HORSHAM DISTRICT COUNCIL CONSULTATION

TO:	Horsham District Council – Planning Dept
LOCATION:	Phases 2 and 3 Land at Wellcross Farm Broadbridge Heath
DESCRIPTION:	Application for Approval of Details Reserved by Condition 2 (Construction Management Plan), ³ (borehole to meet Private Water Supplies), ⁴ (Private Water Supply Management Plan), ⁵ (finished floor levels and external ground levels) and 7 (underground services) to approved application DC/24/0205 Reserved matters application pursuant to condition 5 of outline planning permission DC/19/1897 for the provision of phases 2 and 3 of Land at Wellcross Farm to provide a continuing care retirement community with 94 units of accommodation (C2), with access, infrastructure, open space, landscaping and associated works including an onsite borehole water supply).
REFERENCE:	DISC/26/0012 & DISC/26/0013
RECOMMENDATION:	Advice / Modification / More information.
2nd response in Red	Advice / Modification / More information.

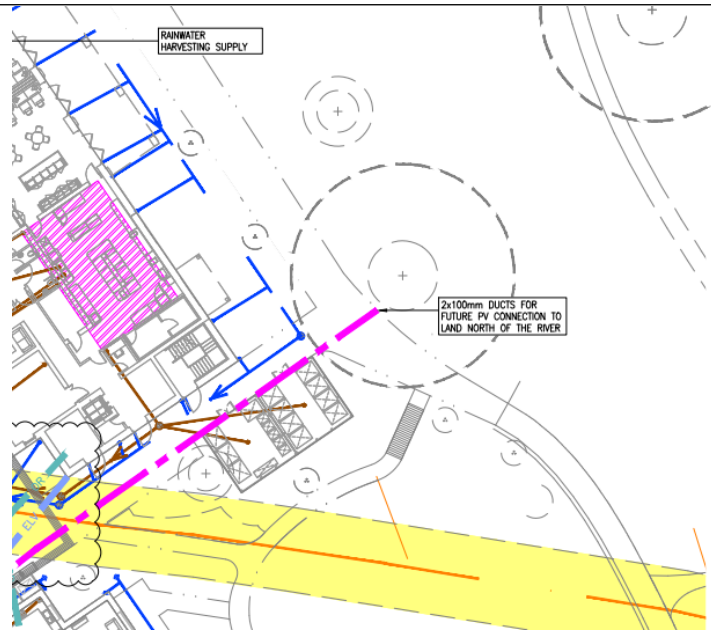
The RPA, of the unknown tree shown in the image above, taken from Electrical & Electrical Services Drawing No. 1163-ESD-XX-00-DR-XX-P2-1001, revision 2, still indicates that the ducts for the future PV connection to land north of the river fall within the tree's RPA. Please seek confirmation that the ducts will be removed and that the PV connection will not be sited within the RPA, or alternatively that trenchless installation methods will be used at a depth greater than 1.5 m below existing ground levels.

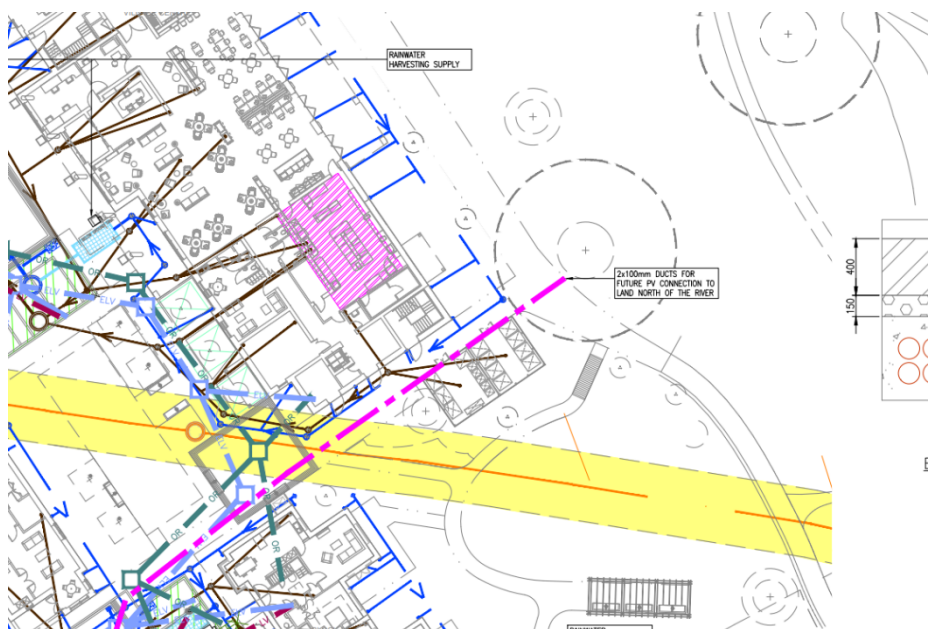
Given the greenfield nature of the site, it is essentially unconstrained. As such, it is not considered that there would be any *overriding justification* for significant development, such as open-trench excavations, to take place within the RPA of retained trees. Ideally, the site layout and design should take appropriate account of existing site constraints, including retained on-site and off-site trees.

Accordingly, amendments should be sought to the route of the service runs to ensure that they do not encroach within the RPA of tree T31, and outside of the RPA, of the unknown tree in the above image taken from Electrical & Electrical Services Drawing No. 1163-ESD-XX-00-DR-XX-P2-1001.

One potential solution would be to relocate the service runs further north, outside the RPA of T31, and outside of the RPA, of the unknown tree in the above image. If this is not

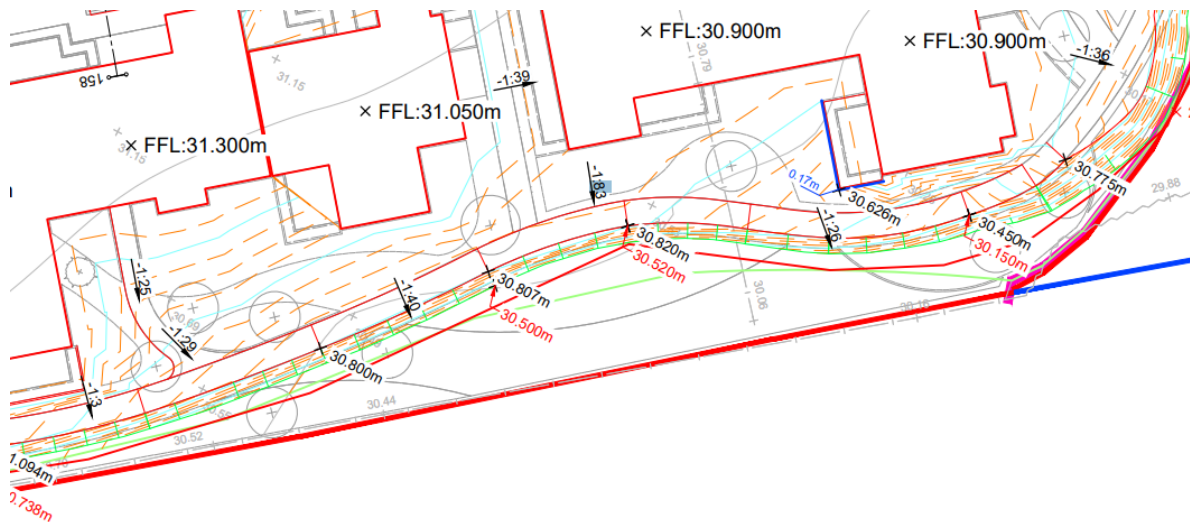
Further concerns are also raised in relation to the proposed landscaping works and associated land level changes in the area to the northwest of off-site trees T30 and T31, both oaks. Given the lack of detail on how the works would be completed without resulting in direct construction damage or indirect post-development harm, including root damage and soil compaction, these proposals are considered problematic. Please seek confirmation on the exact extent of the level changes and landscaping works within the RPA of T30, and T31.
